# Access Compliance Report

## Public Rights-of-Way

### (Curb Ramps)

Intersection ID: 2977	Main Street: ELDESLIE_DR	Cross Street: HARBURN_FOREST_DR	Location: SE
ADA ID: 5C1935328439	Ramp Type: PerpDiag	Initial Pass/Fail: Fail	Overall Compliance: No
Severity Score: 25			
Codes/Mitigation Info/Possible Solution		Field Measurements/Component Compliance

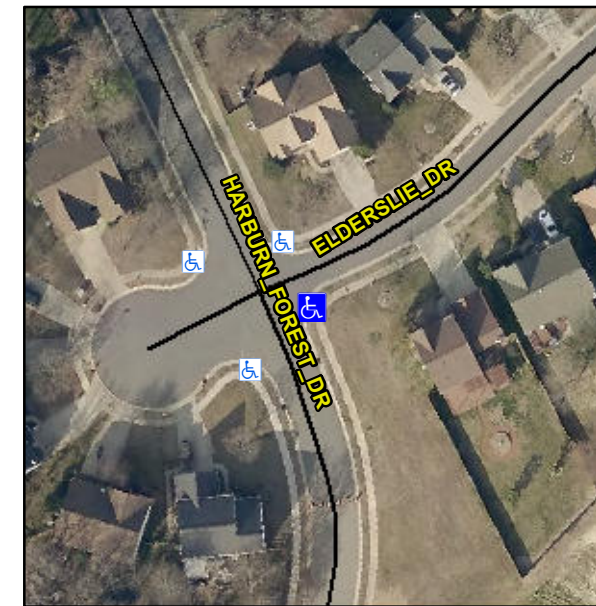
**Not Found, R304.5.3**

Compliance	Description	Data	Compliance	Description	Data
N/A	Ramp Length (in)	63.0	Yes	Ramp Slope (%)	5.8
Yes	Ramp Width (in)	48.0	No	Ramp XSlope (%)	8.1
N/A	Flare Type LT	N/A	N/A	Flare Type RT	N/A
N/A	Flare Slope LT (%)	N/A	N/A	Flare Slope RT (%)	N/A
N/A	Flare Traversable LT?	N/A	N/A	Flare Traversable RT?	N/A
N/A	Landing Length (in)	N/A	N/A	DWS Provided?	N/A
N/A	Landing Width (in)	N/A	N/A	DWS Contrast?	N/A
N/A	Landing Slope (%)	N/A	N/A	DWS Length (in)	N/A
N/A	Landing X Slope (%)	N/A	N/A	DWS Full Width?	N/A
N/A	Landing Curb? (Y/N)	N/A	N/A	DWS Offset (in)	N/A
N/A	Shared Landing?	N/A			
N/A	Gutter Ponding?	N/A	N/A	Gutter Slope (%)	N/A
N/A	Gutter Lip Ht (in)	N/A	N/A	Gutter X Slope (%)	N/A
N/A	Painted X Walk1?	No	N/A	Painted X Walk2?	No
	X Walk 1 Direction	To N		X Walk 2 Direction	To W
N/A	X Walk 1 Width (in)	N/A	N/A	X Walk 2 Width (in)	N/A
	X Walk 1 Slope (%)	1.7		X Walk 2 Slope (%)	6.8
	X Walk 1 X Slope (%)	5.5		X Walk 2 X Slope (%)	0.6

**Remove & Replace Curb Ramp With Two New Directional Ramps or Equivalent.**
